Instrument Technical Guideline

Satelec/Acteon Ultrasonic Display Board Revision History

TG-95-0199

TECHNICAL NOTE: ULTRASONIC DISPLAY BOARD REVISION DESIGN HISTORY

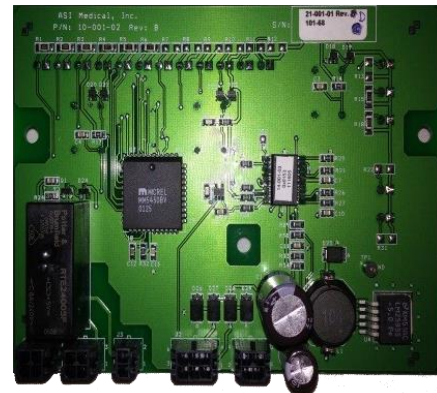
- 01/08/2003 to 10/23/2005 = (Green Satelec Boards)
 = 47-0029 Rev A (LED Indicator Cintron Boards)
 = 47-0029 Rev B (LED Indicator Cintron Boards)
- 10/24/2005 to 01/09/2006 = 47-0029 Rev C (LED Indicator Cintron Boards)
- 01/10/2006 to 04/24/2006 = 47-0029 Rev D (LED Indicator Cintron Boards)
